## Letter of Objection To Wharf Phase 2, Case Number 11-03J (specifically Parcel 10)

October 23, 2017

Figure 1. Calculation of Distance of Parcel 10 extension towards 525 Water

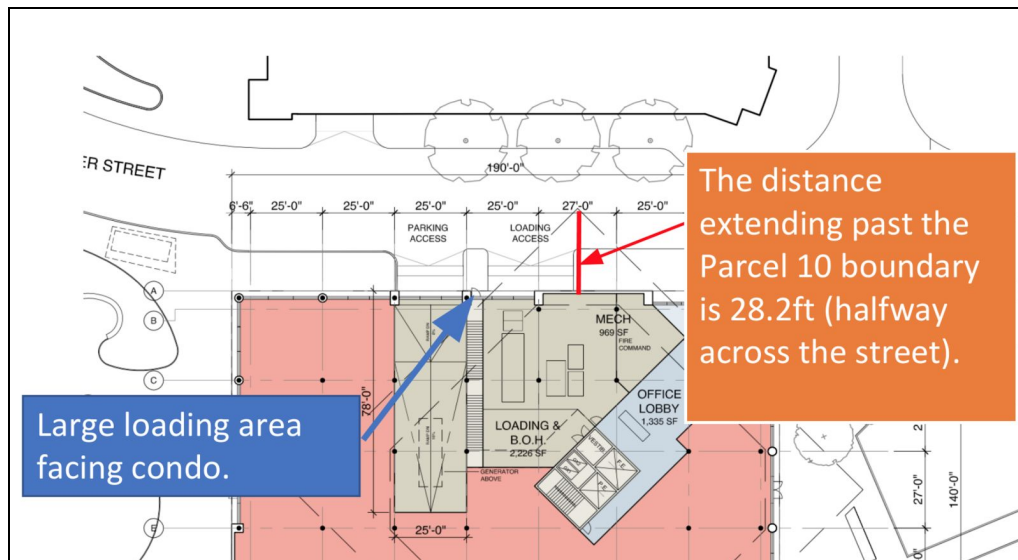
1) **The 45-degree rotation of the upper floors of Parcel 10 results in the corners of the building protruding outside the parcel area and halfway across the street, which creates a significant intrusion.** The corner protruding out onto Water St, and facing 525 Water Condominiums (Parcel 11) measures a distance of 28.2 ft out (Figure 1). This distance extends past the entire sidewalk and crosses halfway across the street. I find this an unacceptable intrusion, and brings into question if the hired architects considered how the building would affect the existing neighboring structures. In fact, most drawings of Parcel 10 do not show 525 Water in relation to other buildings. I also found misleading perspective drawings that showed greater space between the two buildings than actually exist based on measured plans (Figure 2).

Fig 3. Screen Shots illustrating Perimeter of Phase 2, and Parcel 10 exceeding perimeter

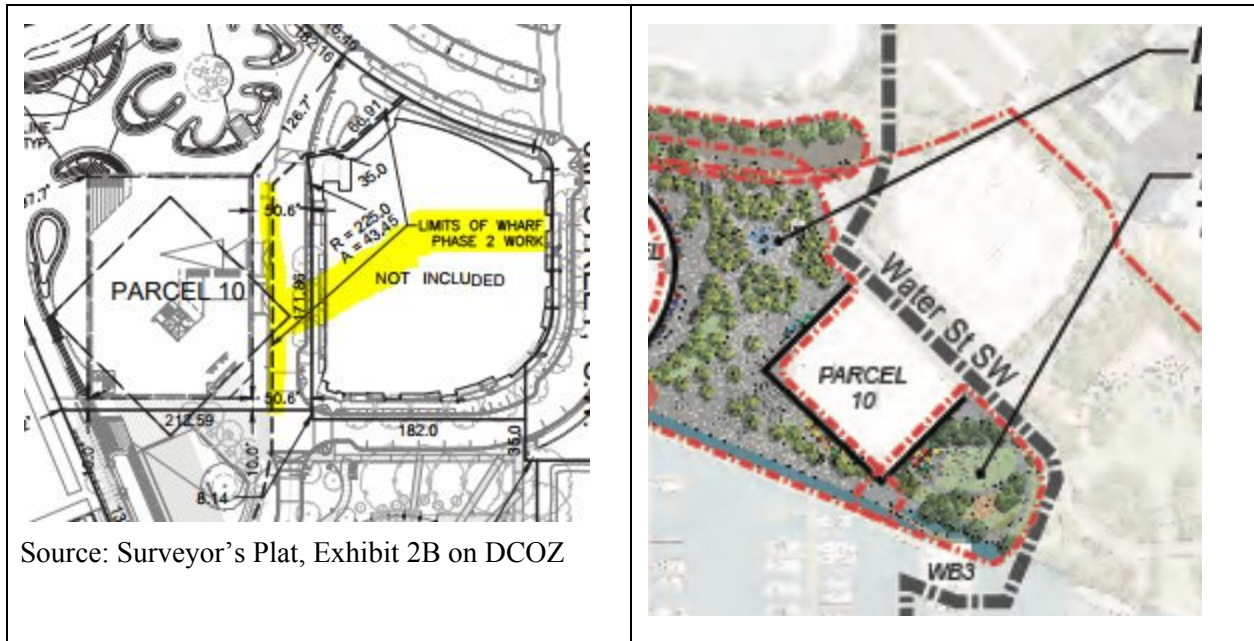
2) **The rotation of the upper floors also appear to result in three (3) corners extending outside the perimeter of Parcel 10, and one (1) corner extends past the perimeter of Phase 2 work.** This should not be permitted. Here I cite the Case Document Exhibit 2B from DCOZ, please note the dotted boundary lines of Phase 2 (Figure 3). The Phase 2 boundary is at the west side of Water Street, excluding the the street itself. The ground boundary of Parcel 10 is a square perimeter. Currently, the corners of the top floors of Parcel 10 extend outside both the Parcel 10 and Phase 2 boundary.
